CAPRICORN MUNICIPAL DEVELOPMENT GUIDELINES

2023 MEETING 9 MINUTES

Venue: GRC Offices in Calliope
Date and Time: 16th November 2023 at 10:00 am

CMDG-R-101: under road 900mm – 100/150mm, 1000mm – 225/300mm

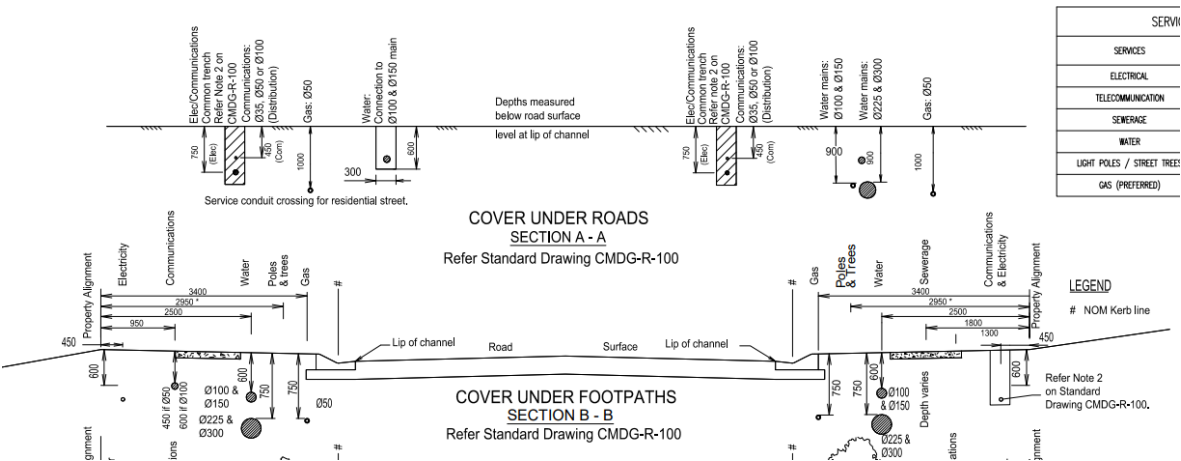
It has been noted that CMDG contains different depths for watermains across the drawings and specifications. There is also some ambiguity between whether a driveway counts as vehicular loading.

Footpath 600mm – 100/150mm, 750mm - 225/300mm

Drawing CMDG-R-101 to be updated to remove sizing information.

CMDG-R-101A: Under road shown as greater than 750mm and less than 900mm

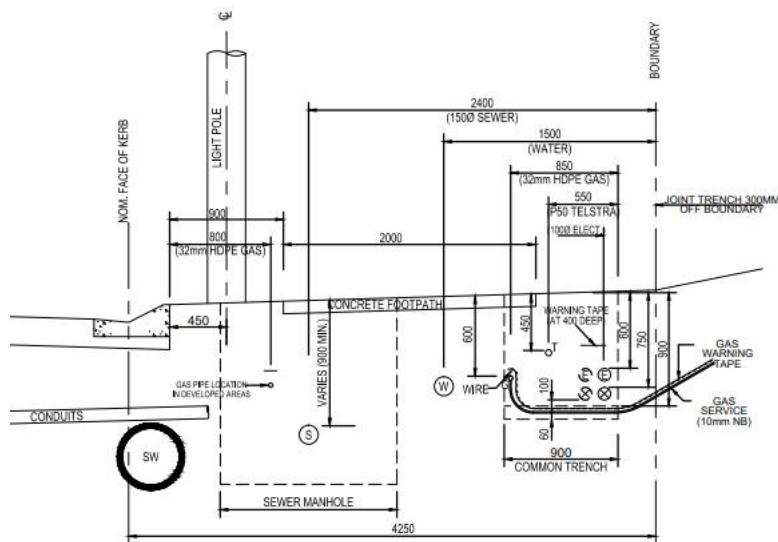
Footpath 600mm

CMDG-W-040: 600mm PVC/ 300mm DICL – non trafficable verge

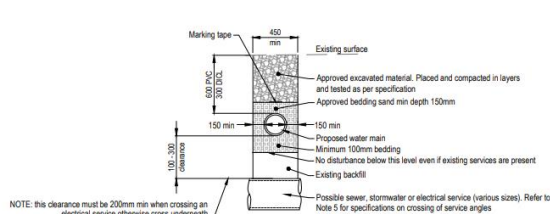
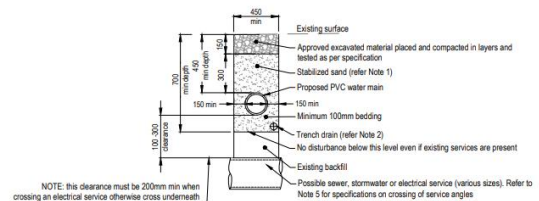
Note that there is no detail for standard construction in the road.

Drawing CMDG-W-040 to be updated to include a "standard" trench detail for in the road
